## REVISED RESPONSE TO REQUEST FOR ADDITIONAL INFORMATION

### APR1400 Design Certification

Docket No. 52-046

RAI No.: 29-7926  
SRP Section: 03.02.01 – Seismic Classification  
Application Section: 3.2.1  
Date of RAI Issue: 06/15/2015

Figure 9.2.2-1 Component Cooling Water System Flow Diagram (Sheet 2 of 4)

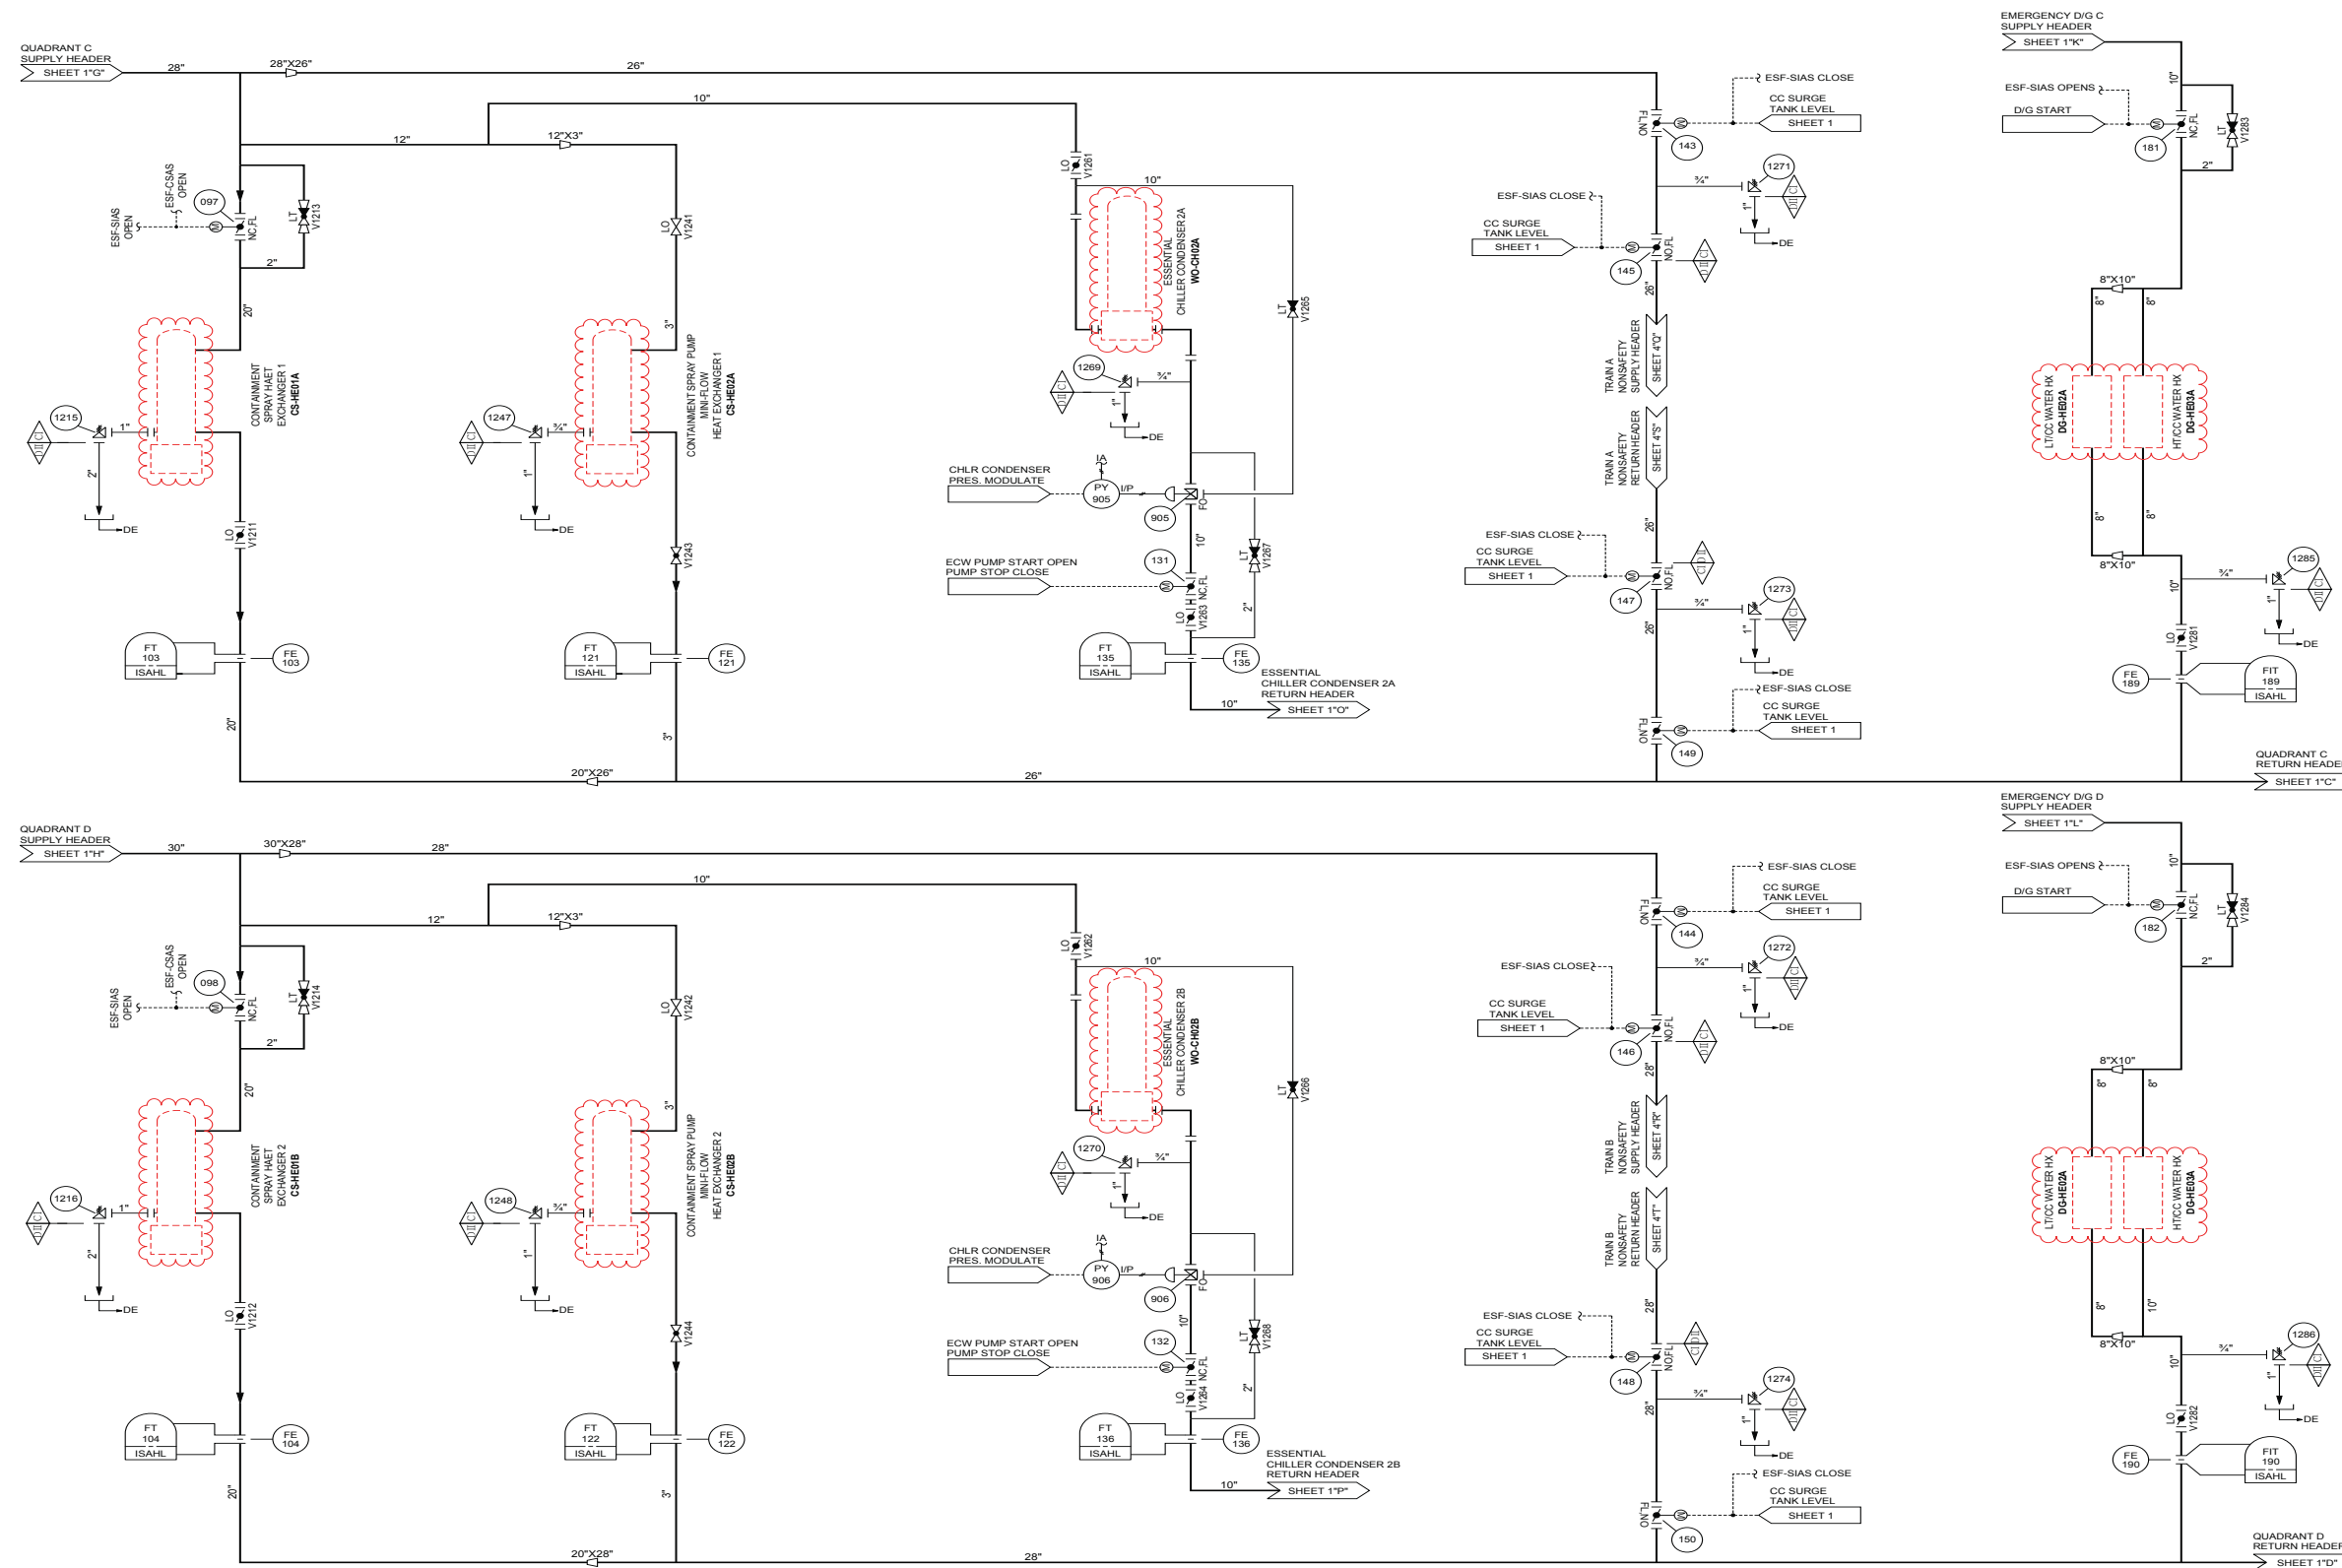
In DCD Tier 2, Table 3.2-1, the letdown heat exchanger supply and return piping between the valves CC-297, CC-301, CC-1685, and CC-1686 in division I, which appears to be part of the component cooling water system (CCW), is identified as seismic Category II, Quality Group D. This is supported in Figure 9.2.2-1 (Page 9.2-149). The letdown heat exchanger itself (part of the chemical and volume control system (CVCS)) is classified as seismic Category I, Quality Group C. This transition is not illustrated in the system figure. Please justify why a portion of CCW, a safety-related system, is not seismic Category I, and why its classification is not consistent with the heat exchanger that it supports. Updates to DCD Tier 2, Table 3.2-1 and associated system figures may be needed to clarify these classifications.

This revised supplemental response is to clarify the specification difference of the shell and inlet/outlet piping portions of the CCW side of the letdown heat exchanger and to provide clear piping specification notation on the flow diagrams for the CCW system, Figure 9.2.2-1, of the DCD.

The shell side of the letdown heat exchanger is classified as seismic Class I, Quality Group C. Though the CCW cooling function for the heat exchanger is non-safety related, the shell was classified to a higher quality level to conservatively provide a higher degree of mechanical integrity of the heat exchanger and to provide uniformity in the overall manufacturing requirements of the heat exchanger. It was determined that there was no safety benefit for increasing the integrity requirements of the shell side inlet and outlet heat exchanger piping and that the classification should be consistent with the connected CCW piping.

The flow diagram for the CCWS will be revised to note the class break between the letdown heat exchanger shell and inlet/outlet piping .

In addition, the flow diagram for the CCWS will be revised for equipment not included in the CCWS to be marked in dotted line as indicated in Attachment.

DCD Tier 2 Figure 9.2.2-1 will be revised as indicated on the attached markup.
